Re: Submission on IPART's Draft Assessment of Austral Leppington North Contributions Plan for Liverpool City Council

Appendix A _ Civil Engineering Matters

Figure 1. Planned open space and recreation reserves in the Western Sydney Parklands

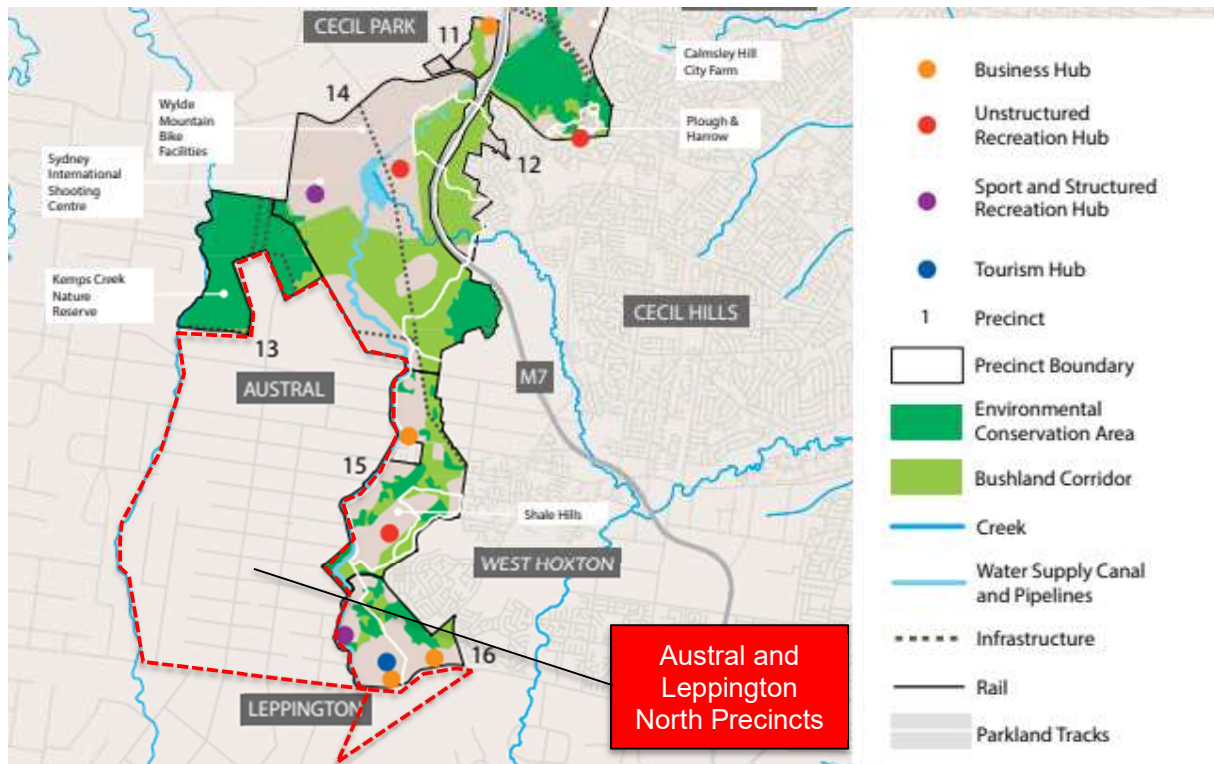
From review of Table 4.7 in IPART's review, it implies that there is a provision of 1.94ha of open space per 1,000 people versus the allocation of 2.08ha/1,000 people stated in Contributions Plan 2021. It is not clear as to whether the 1.94ha is an accurate reflection of the allocation of open space. For instance, Council already owns 13.5ha of open space land that, per the Contributions Plan 2021, served some 2,659 people (associated residents of the existing 782 dwellings in the precincts). This would equate to a rate of provision of 5ha/1,000 people, well over Council's minimum standard with a surplus of 2.247ha of open space per 1,000 people available or additional 5.975ha of additional open space that would go towards catering for the incoming additional population in Austral and Leppington North.

However, IPART's calculation of 1.94ha does not seem to recognise the existing rate of provision and associated apportionment over the whole of the Precincts. For instance a rate of provision 1.94ha based on 55,078 people identified in the plan equates to 106.6ha, it fails to recognise the surplus open space already available in Austral and Leppington North (some 5.975ha).

As this figure will presumably be utilised by Council to inform future open space planning and potential changes to the Contributions Plan 2021, this figure should be clarified and confirmed. Further, it should be noted, as referenced in IPART's report, that Council was part of the Precinct Planning process for the Austral and Leppington North Precincts led by the Department of Planning and Environment that had agreed to the lower rate of provision of open space presumably due to the proximity to the Western Sydney Parklands future open space projects identified in their masterplan provided in their Plan of Management that identifies 2 Sport and Structured Recreation

Recommendation 4.1: As part of finalising their report on the Contributions Plan, IPART should clarify the calculations in Table 4.7 relating to the planned open space in the Austral and Leppington North Precincts, in particular the rate of provision, that will be used to inform future open space planning by Council.

Figure 8 - Dwelling growth over time in each Precinct

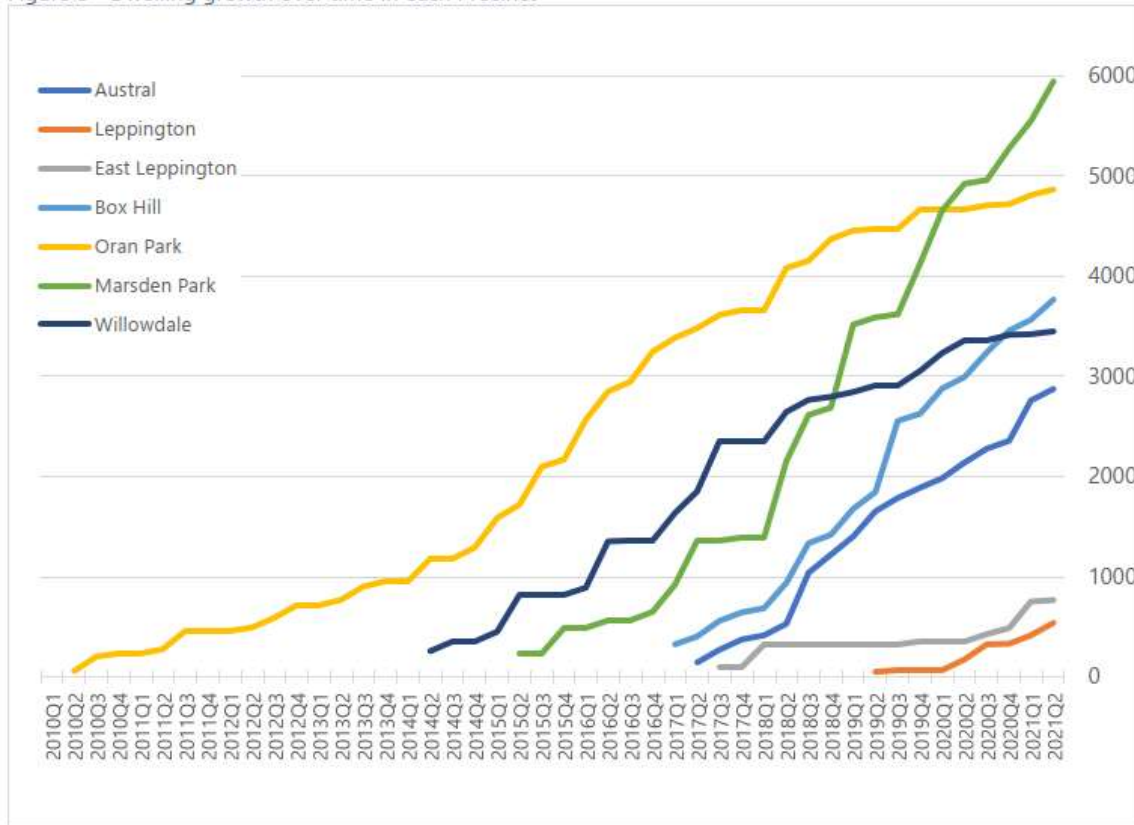
Whilst not the specific remit of IPART, there appears to be no holistic consideration by Government as to the effects of implementing new infrastructure reform on housing supply in Sydney's Growth Areas. Based on significant investment by utility providers and developers, the Austral and Leppington North Precincts have been able to establish a delivery pipeline that now makes a significant contribution to housing supply in Sydney's South West with almost 700 lots/housing per year (see below).
